**PRODUCT SUPPORT BULLETIN
BULLETIN NO. 299**

MACHINE: Anchor Applicator Model E

SUBJECT: Pump Shaft Seal Failures

Figure 1

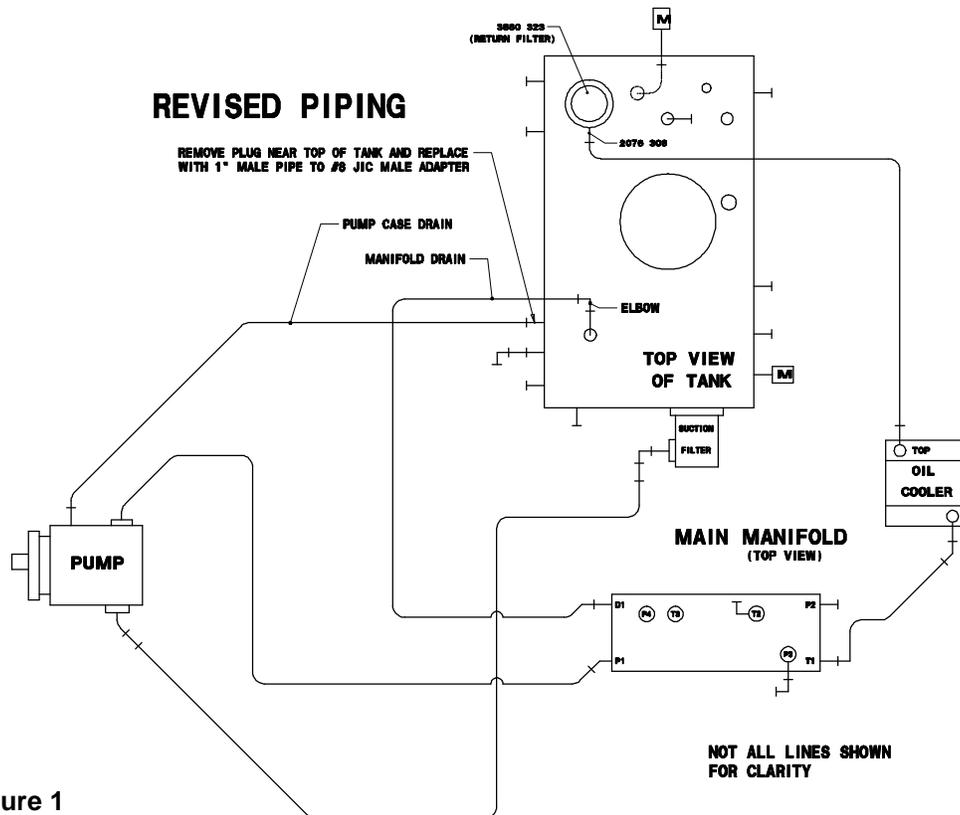
There have been some reports of the pump shaft seal failing on these machines. The pump case drain line is connected together with the drain line from the manifold. Pressure spikes from the manifold drain are seen in the pump case drain line. These pressure spikes cause the shaft seal failure.

To prevent this problem, the pump case drain and manifold drain hoses must be separated. The two lines come together at a port in the top of the tank. Refer to Figure 1. Remove the hoses, the tee and the elbow from the tank port. Re-install the manifold hose into this port using only the elbow. Discard the tee. Remove the 1" pipe plug from the engine side of the tank. This plug is approximately 4" down from the top. Install a 1" male pipe to #8 male JIC adapter in the port. Connect the pump case drain hose to this adapter.
